# Pulse

## Product Change Notification

<b>PCN Date:</b>	2024/7/10																						
<b>Supplier Name:</b>	PULSE ELECTRONICS																						
<b>Pulse PCN No.</b>	PCN-100000663 Rev A																						
<b>Description of Change</b>	Add 2nd manufacturing site and product upgrade with side plating. No impact to product fit or function.																						
<b>Reason for Change</b>	<ol style="list-style-type: none"> <li>Based on company's strategy, add 2nd manufacturing site for mitigate supply risks per business contingency plan requirement.</li> <li>In order to improve solderability performance and increase terminal strength, the products upgrade with side plating.</li> </ol>																						
<b>Summary of Changes between the new and old part</b>	<table border="1"> <thead> <tr> <th>Present part</th> <th>New part</th> </tr> </thead> <tbody> <tr> <td>Part number: PE-1812ACCXXXSTS</td> <td>Part number: PE-1812AGCXXXSTS</td> </tr> <tr> <td>Manufacturing site: Selangor, Malaysia</td> <td>Manufacturing site: 1. Selangor, Malaysia 2. Dongguan, China</td> </tr> </tbody> </table>	Present part	New part	Part number: PE-1812ACCXXXSTS	Part number: PE-1812AGCXXXSTS	Manufacturing

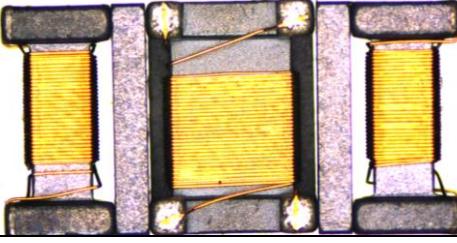
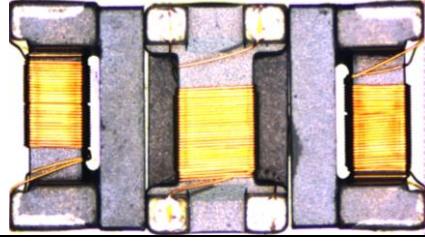
Present part	New part																						
Part number: PE-1812ACCXXXSTS	Part number: PE-1812AGCXXXSTS																						
Manufacturing site: Selangor, Malaysia	Manufacturing site: 1. Selangor, Malaysia 2. Dongguan, China																						
	<p>Without Slide plating</p> 	<p>With slide plating</p> 																					
	<p><b>Dimension comparison</b></p> <table border="1"> <thead> <tr> <th>Part No.</th> <th>PE-1812ACC101STS</th> <th>PE-1812AGC101STS</th> </tr> </thead> <tbody> <tr> <td>Constructre</td> <td>  </td> <td>  </td> </tr> <tr> <td>Length A</td> <td>4.5+/-0.2</td> <td>4.5+/-0.2</td> </tr> <tr> <td>Width B</td> <td>3.2+/-0.2</td> <td>3.2+/-0.2</td> </tr> <tr> <td>Height C</td> <td>3.0 max</td> <td>3.05+/-0.2</td> </tr> <tr> <td>pad length E1</td> <td>0.7 ref</td> <td>0.6+/-0.1</td> </tr> <tr> <td>Pad Width E2</td> <td>0.65 ref</td> <td>1.0+/-0.1</td> </tr> </tbody> </table>		Part No.	PE-1812ACC101STS	PE-1812AGC101STS	Constructre			Length A	4.5+/-0.2	4.5+/-0.2	Width B	3.2+/-0.2	3.2+/-0.2	Height C	3.0 max	3.05+/-0.2	pad length E1	0.7 ref	0.6+/-0.1	Pad Width E2	0.65 ref	1.0+/-0.1

Part No.	PE-1812ACC101STS	PE-1812AGC101STS																					
Constructre																							
Length A	4.5+/-0.2	4.5+/-0.2																					
Width B	3.2+/-0.2	3.2+/-0.2																					
Height C	3.0 max	3.05+/-0.2																					
pad length E1	0.7 ref	0.6+/-0.1																					
Pad Width E2	0.65 ref	1.0+/-0.1
